APPENDIX L COMMENTS ON THE DRAFT EIS AND RESPONSES

TABLE L-1			
Comments Received on the Draft EIS				
Letter Number	Agency/Commenter Name	Date of Letter/ Comment Session	FERC Docket Accession Number	
FEDERAL AGEN	CIES (FA)			
FA01	NOAA National Marine Fisheries Service	2/5/19	20190206-5004	
FA02	United States Coast Guard, Margaret Brown	2/5/19	20190205-5000	
FA03	United States Environmental Protection Agency	3/12/19	20190312-5206	
FA04	United States Department of Interior	3/13/19	20190313-5200	
STATE AGENCIE		-		
SA01	Texas Commission on Environmental Quality	1/22/19	20190122-0008	
SA02	Texas Parks & Wildlife Department	2/4/19	20190204-5206	
SA03	Railroad Commission of Texas	3/1/19	20190308-5128	
SA04	Railroad Commission of Texas	3/6/19	20190315-0010	
LOCAL AGENCIE			1	
LA01	Port of Brownsville	1/29/19	20190201-5216	
	D ORGANIZATIONS (CO)			
CO01	Suntrack Supply Services Inc	1/22/19	20190122-0007	
CO02	Greater Brownsville Incentives Corporation	1/18/19	20190125-0041

FIGURE 4.13.2-1 Cumulative Impacts (Rio Grande LNG, Texas LNG, Annova LNG, and Background Concentrations), 1-Hour NO₂

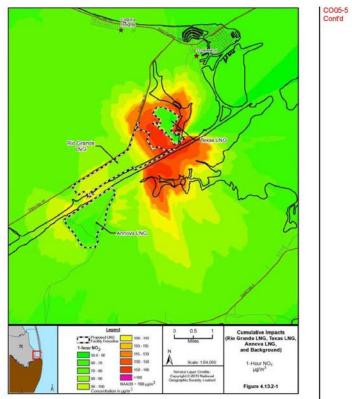
In addition, Figure 4.13.2-1 that FERC developed and included in the DEISs for both the Rio Grande and Texas LNG projects illustrates the cumulative modeled impacts for 1-hour NO2 and the spatial distribution of the peak concentration.7.8 Annova requests that FERC use this figure to further clarify the Project's potential contribution to this scenario.
